Drawn By			
Title			
485			
Size	Project Name		Rev
A	ZONE 4X4		1.0
Date:	Tuesday, August 30, 2011		Sheet 1 of 6

Title		
REVISIONS		
Size B	Document Number ZONE 4X4	Rev 1.0
Date:	Tuesday, August 30, 2011	Sheet 6 of 6

Drawn By		
Title		
KeypadDisplay		
Size	Project Name	Rev
B	ZONE 4X4	1.0
Date:	Tuesday, August 30, 2011	Sheet 2 of 6

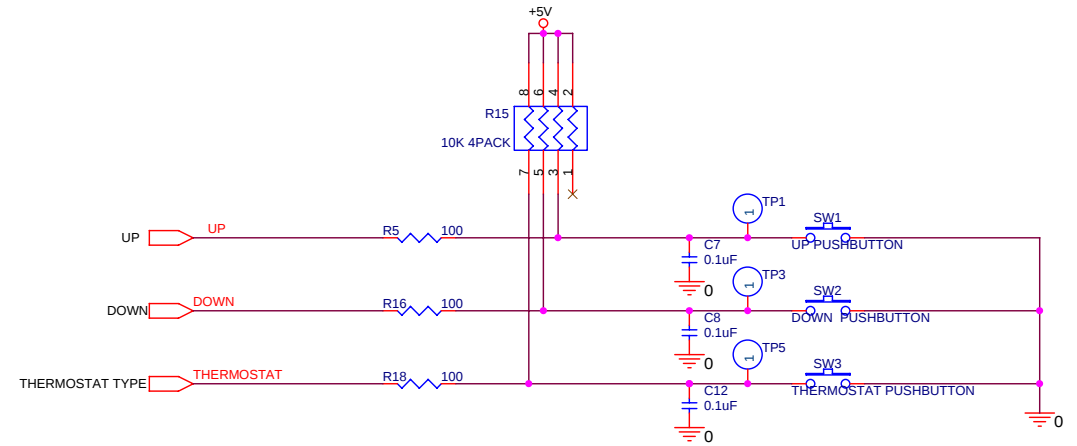
Done: Change label on sw3 from " STAT TYPE PUSHBUTTON" to " THMOSTAT PUSHBUTTON";
Done: Add test point connections to TXD1 and RXD1 on U2-13 & U2-14;
Done: Change the COMM SELECT switch circuit;
Done:Change the Display from " FRESH AIR " to " DELAY ECO";

Drawn By		
Title		
MCU		
Size	Project Name	Rev
B	ZONE 4X4	1.0
Date:	Tuesday, August 30, 2011	Sheet 3 of 6

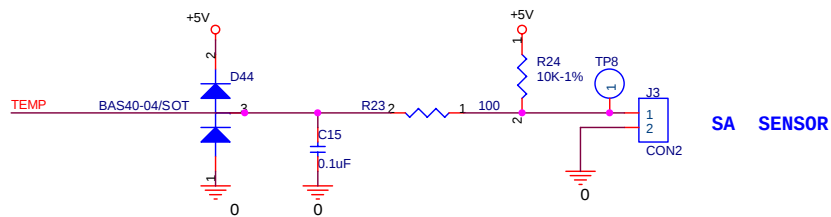
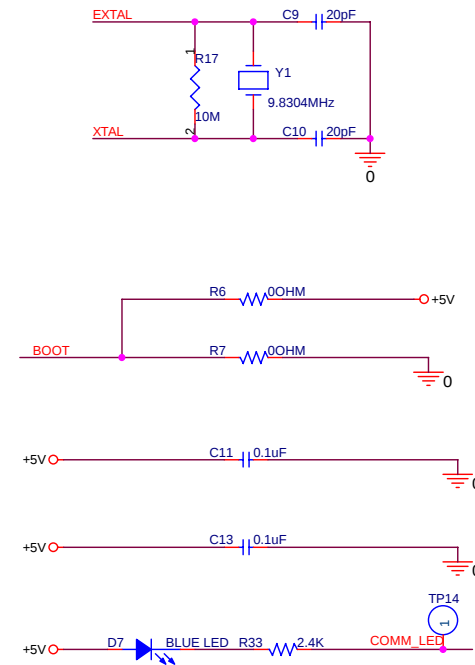
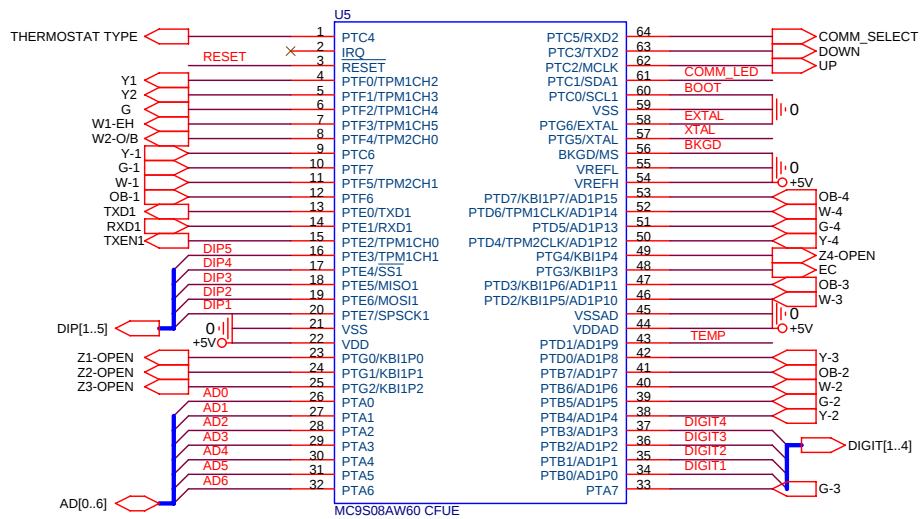
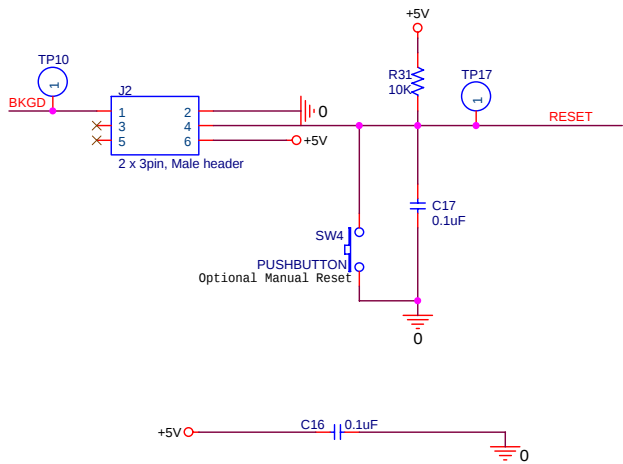
Done: Move EC from pin13 to pin48;
Done: Add one COMM port;
Done: Remove the OP call dip switch
Done: Remove MODE ALL Dip switch
Done: Add a slide switch by COMM port;
Done: Delete Fresh damper;
Done: Delete the Fresh Air Time Switch;

Title		
Power Supply		
Size B	Document Number ZONE 4X4	Rev 1.0
Date:	Tuesday, August 30, 2011	Sheet 5 of 6

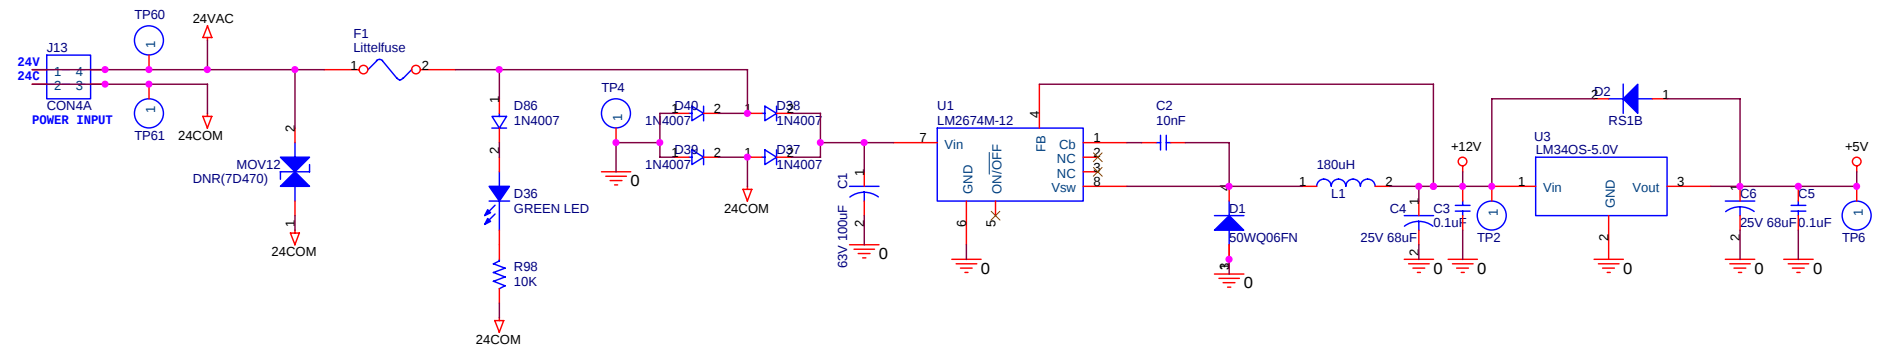
Done: ADD MOVs Between PC and 24com;

Done: ADD MOVs Between P0 and 24com;

Done: ADD MOVs Between PC and 24com;
Done: CHANGE the SW4 from DIP5 to DIP6,Delete the SW6, put COMM_Select
together with SW4.
